**City of Ramsey**  
**Agenda**  
**City Council Work Session**  
**Tuesday November 20, 2012**  
**Immediately Following Public Works Committee**  
**Lake Itasca Room 7550 Sunwood Drive NW**

Review Request for Alternative Mechanical Screening at 7333 Sunwood Dr NW; Case of NAU Country Insurance Company

**2ND FLOOR PLAN & SITE PLAN**  
DATA CENTER PROJECT  
NAU COUNTRY INSURANCE  
7333 SUNWOOD DRIVE NW  
RAMSEY, MN 55303

**1 OUTDOOR EQUIPMENT YARD**  
1/8" = 1'-0"

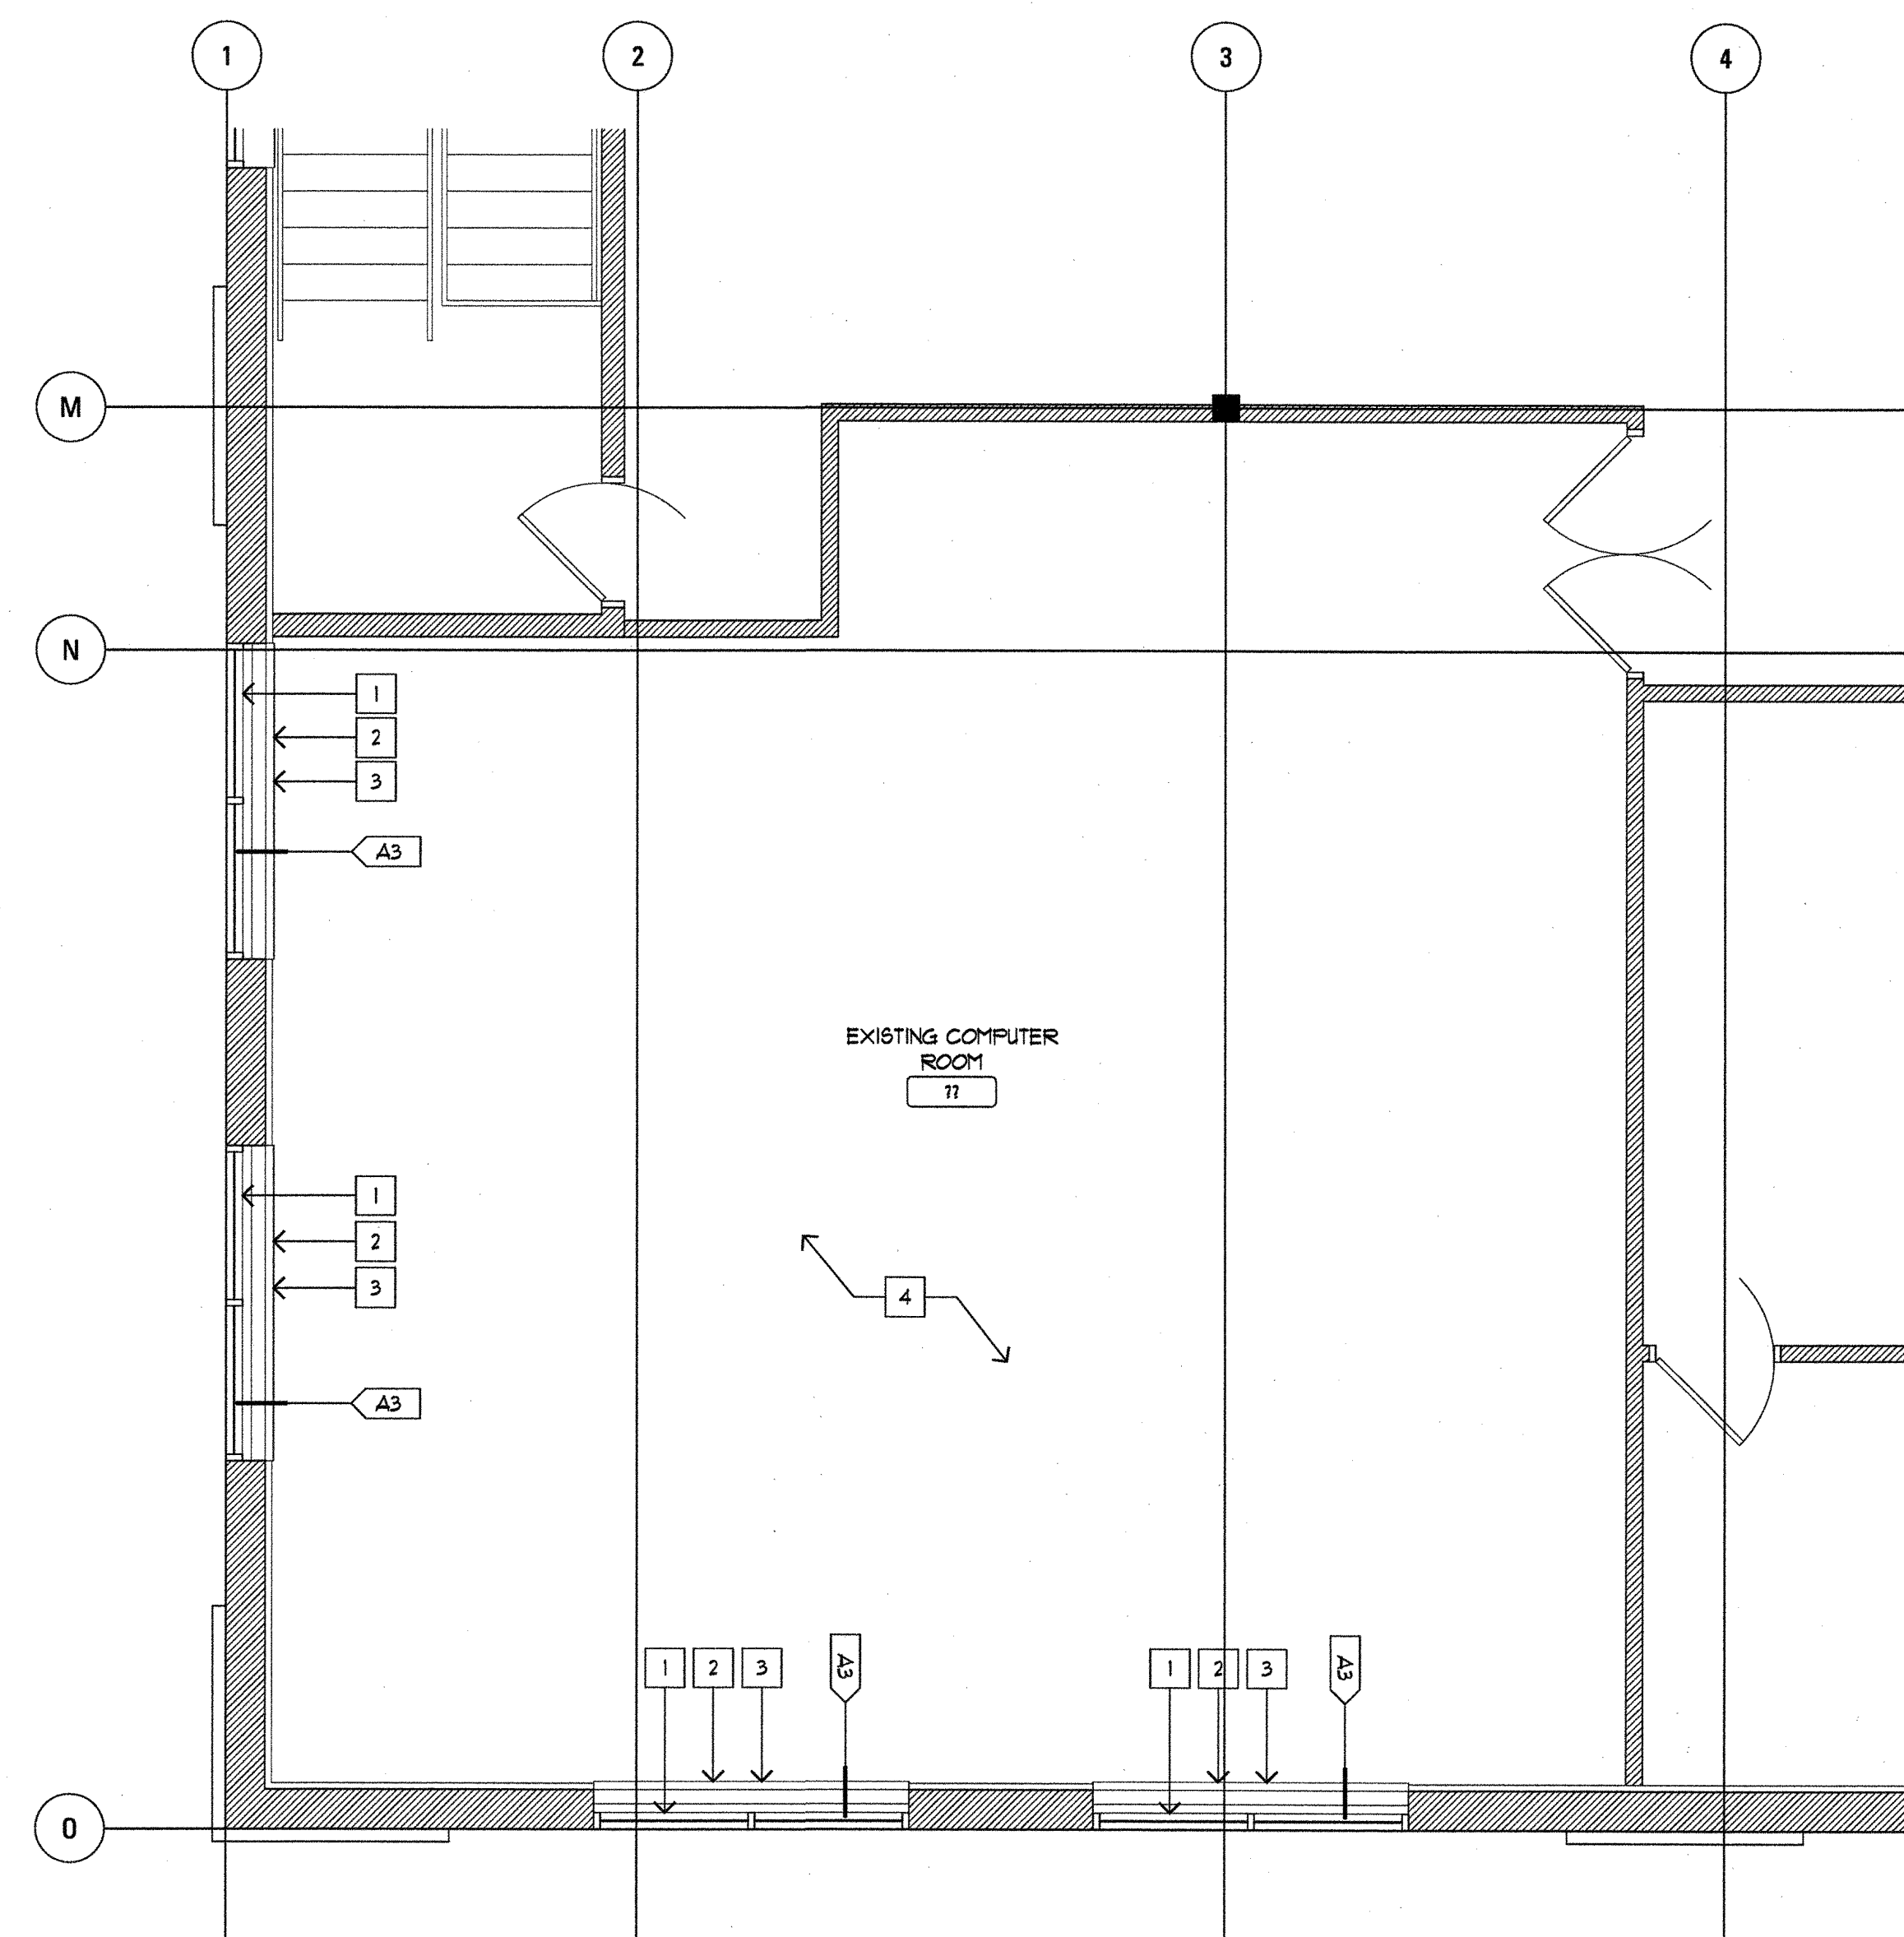
The request includes upgrades to the data center portion of the building, and requires upgrades and additions to certain mechanical equipment, including a second transformer, a backup/emergency generator, and four pieces of cooling equipment proposed to be constructed at ground level west of the existing building along Sunwood Drive. The Design Framework for The COR (City Code) states on page 28 that "equipment, mechanical systems, transformers, etc. must be screened from view in a way that is integral to the architecture of the building; screening should be accomplished with materials similar to or compatible with materials used on the main structure; metal fencing or mechanical vent screens alone are not sufficient." The Applicant is proposing to utilize a vinyl coated, mesh fabric covered chain-link fence with vegetative screening along Sunwood Drive.

The Design Framework sets minimum design standards for all future development to follow in The COR, including architectural standards. The Framework also allows some flexibility in creativity in design, provided that the design intent is met. Certain architectural review can be approved administratively by Staff. Some architectural approval requires consideration and approval by the City Council. Staff believes that the current proposal is not a design that Staff could approve administratively under current City Code, but may be a proposal that could be approved by City Council. There are six larger pieces of mechanical equipment in close proximity to Sunwood Drive.

In its review, Staff divided the review into primary mechanical equipment (transformer and backup generator) and accessory mechanical equipment (cooling system). As the electrical transformer and generator serve a primary purpose related to the functional capability of the building and placement is somewhat dependent upon placement by the utility company, the City has allowed flexibility in screening for these components. The City has consistently required that this accessory mechanical equipment be screened in some capacity.

Ideally, Staff would recommend a combination of fencing and architectural wall as a solution to the mechanical equipment needs of NAU Country Insurance and the screening requirements of City Code. Staff would recommend, under current City Code, a screening wall with materials compatible with the existing building along Sunwood Drive, and the use of the proposed fence for the remaining two (2) sides.

Alternatively, Staff would support the use of fencing and vegetative screening, if the City Council decides that this is an acceptable screening mechanism for future development. Staff would recommend documenting this policy at a future date to guide future reviews administratively. Staff recommends that vegetative screening include a maintenance agreement and surety to ensure long-term maintenance and survival. The Design Framework is intended to provide baseline design standards, while encouraging and providing for creative and flexibility in design.

Motion to approve/deny the request for mechanical screening with use of a vinyl coated, chain-link fence with mesh fabric and vegetative screening along Sunwood Drive.
